**VILLAGE OF BARTLETT
PLAN COMMISSION
AGENDA**

**BARTLETT MUNICIPAL CENTER
228 MAIN STREET
August 11, 2016**

DATE: August 1, 2016
TO: The Chairman and Members of the Plan Commission
FROM: Roberta B. Grill, Assistant Com Dev Director *RBG*
RE: **(#15-13) BAPS**

DATE: August 1, 2016
TO: The Chairman and Members of the Plan Commission
FROM: Roberta B. Grill, Assistant Com Dev Director *RBG*
RE: **(#16-05) Ashton Gardens**

FIGURE 1. Ashton Gardens – Site Plan Considerations

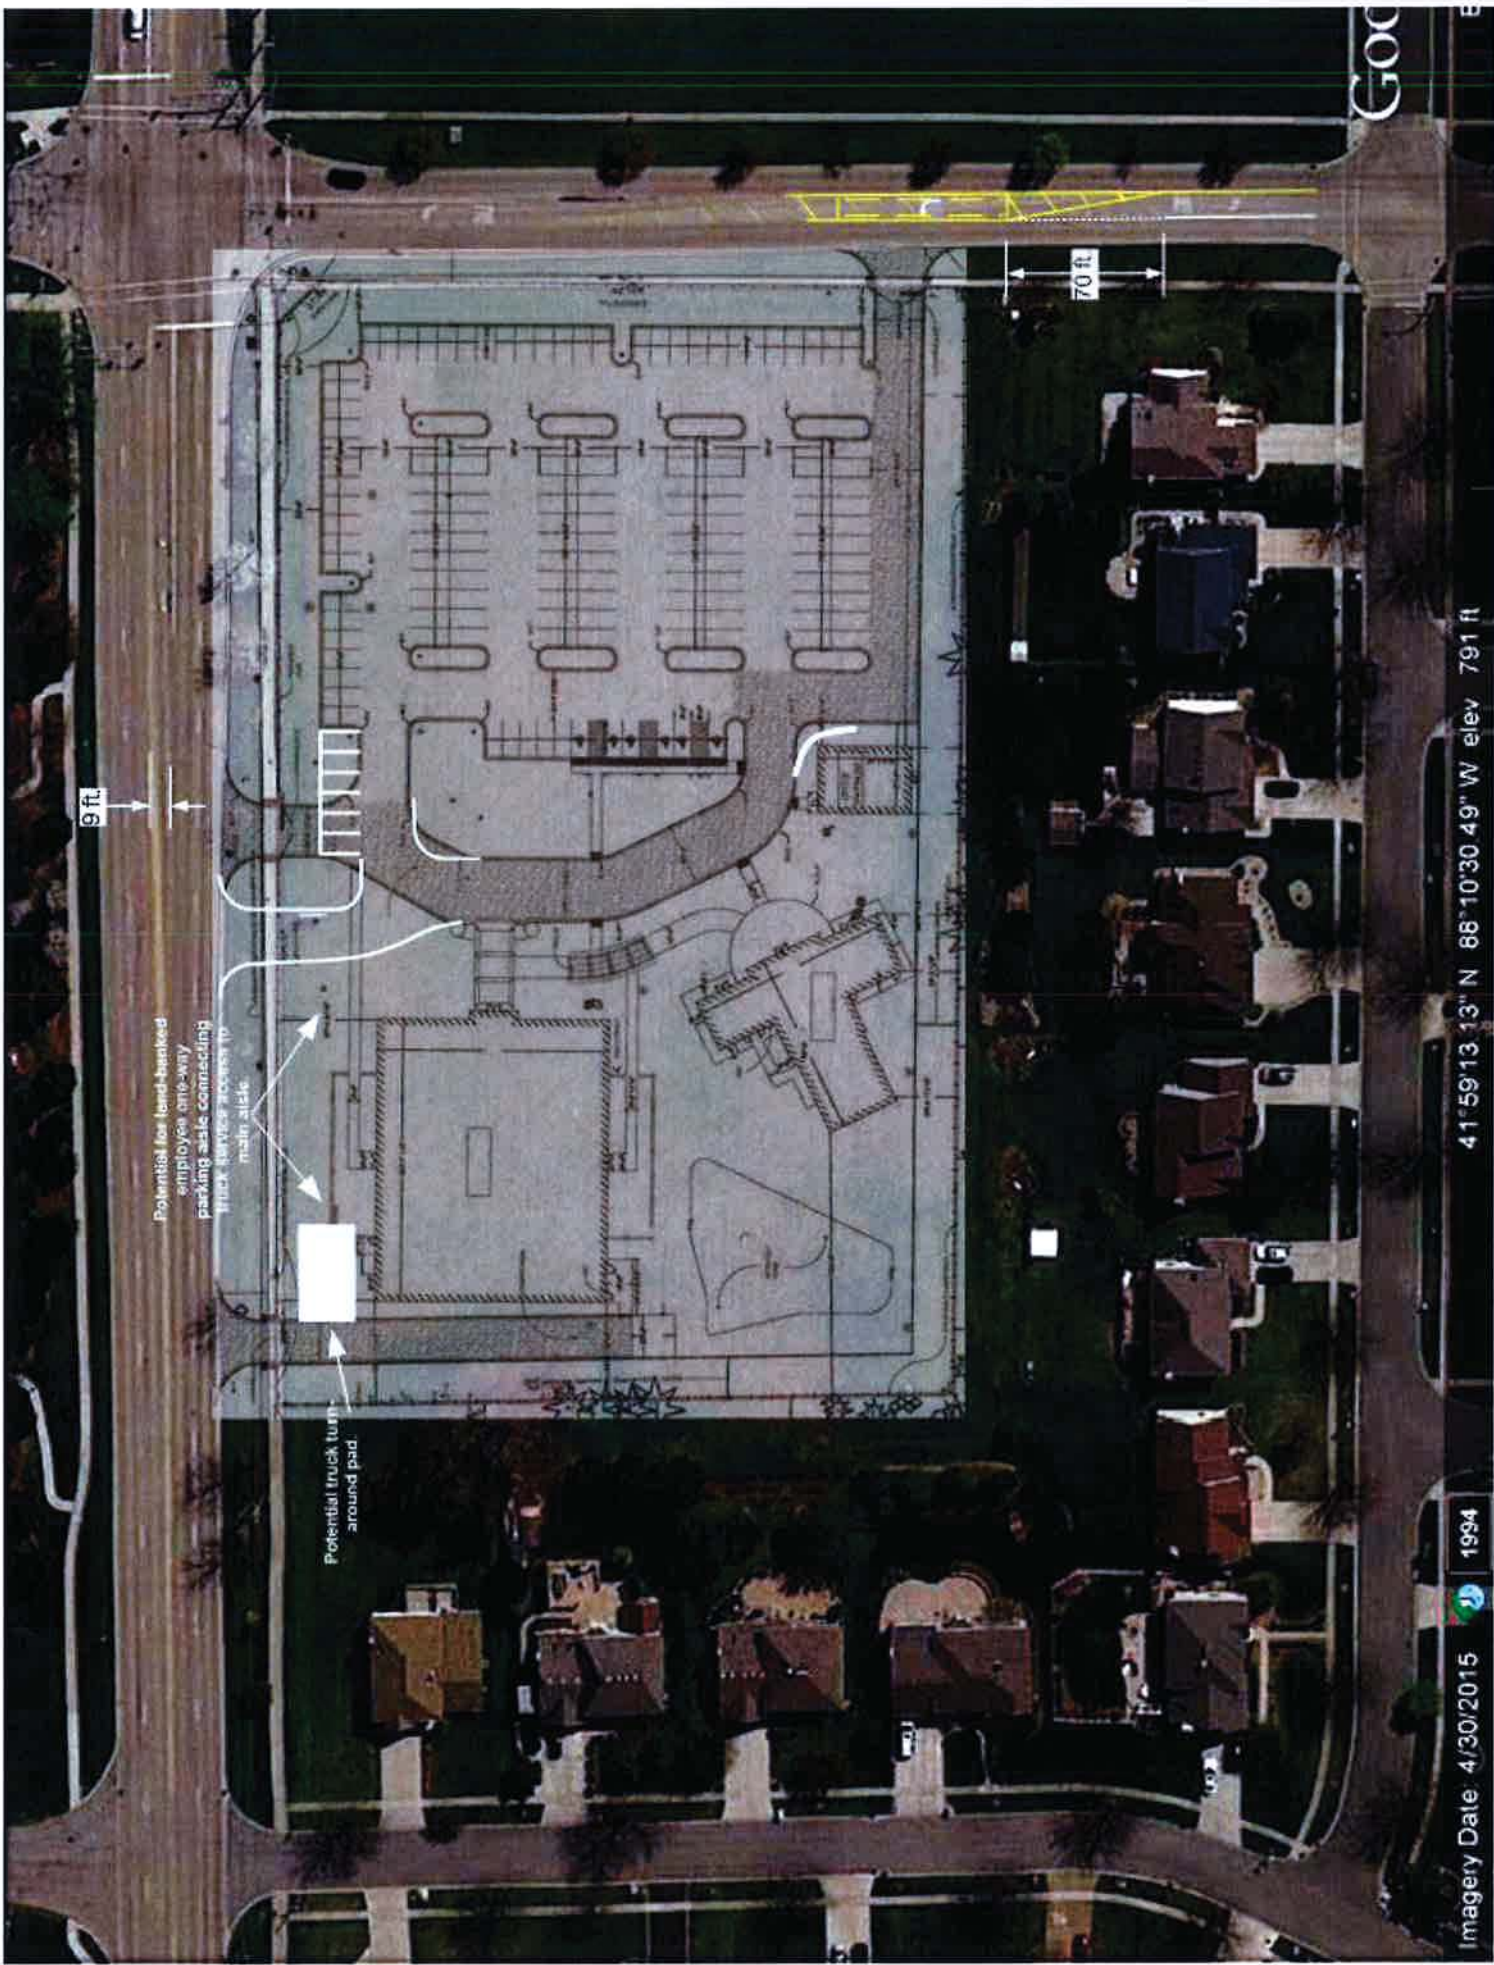
As shown in Figure 1., the Devon Avenue access is located approximately 220 feet west of Prospect and falls opposite the striped taper median area for the EB left-turn lane on Devon at Prospect. At this point the EB tape width is approximately 9 feet and in such cases there may be a tendency for WB left-turns into the site to straddle this median area as they wait to make their turn. One consideration would be to relocate this access to the west as shown in Figure 1. This could also result in the addition of +/- 6 parking spaces (see parking review that follows). In any event, this part of Devon Avenue is under the jurisdiction of DuPage County and they would have final authority on access location. Relocation of the driveway to the west also improves exiting sight lines relative to vehicle queued on red indications on Devon at the Prospect Ave. signal.

The Prospect Avenue access shown on the Site Plan falls generally opposite a diagonally striped median and beginning of a SB left-turn lane taper serving Lido Terrace. Under the same rationale as discussed above, it may be advantageous to consider restriping this median area on Prospect to provide a legal left-turn storage area for inbound site left-turns while still maintaining the SB left-turn lane (with reduced taper length) for Lido Terrace as shown in Figure 1.

A separate truck service berth and refuse truck access is provided by a separate truck-only access on the west side (rear) of the reception hall building. This would require service vehicles or fire trucks to back out onto Devon Ave., but maximizes green area on the site and separates trucks from guest traffic. A turn-around pad for smaller delivery trucks could be considered south of Devon on this service drive (see Figure 1.).

An aerial fire truck turning path exhibit was provided in support of the Site Plan and shows a vehicle just able to navigate the around the winding parking access aisle at the south end of the site near the office building. The Village should determine if this design vehicle adequately reflects wheelbase, length and turning radii of their own fire equipment. I would suggest consideration of modifying the curb line near the office building area if possible, as shown in Figure 1 (this may require some minor shifting of the office building further west).

As noted earlier an additional/ +/- 6 parking spaces if the main access drive were relocated further west and consideration of land-banked employee spaces (a one-way aisle to minimize depth) may be of interest on the north side of the building (see Figure 1.).

Consider relocating the main access on Devon further west (Figure 1.) to move it away from the EB left-turn lane entry taper on Devon at Prospect (this could also create potential for added parking spaces internally). Consider restriping the median area north of Lido Terrace to maintain the existing SB left-turn lane but add legal median left-turn storage for the proposed site access (see Figure 1.).

There is no internal connection for the rear (reception hall) loading berth. Service trucks will be forced to back out onto Devon. A truck turn-around pad could be considered near the northwest corner of the reception hall (Figure 1.).

Fire truck access through the main parking access aisle is tight. Verify that the design fire vehicle is compatible with the Village design fire truck and consider a slight modification to the curb line in the vicinity of the office building (see Figure 1.).

Relocation of the main Devon access drive to the west would create an additional +/- 6 guest parking spaces. Land banked employee parking (one-way aisle) could be considered on the north side of the reception hall connecting the service drive to the main Devon access drive (Figure 1.).
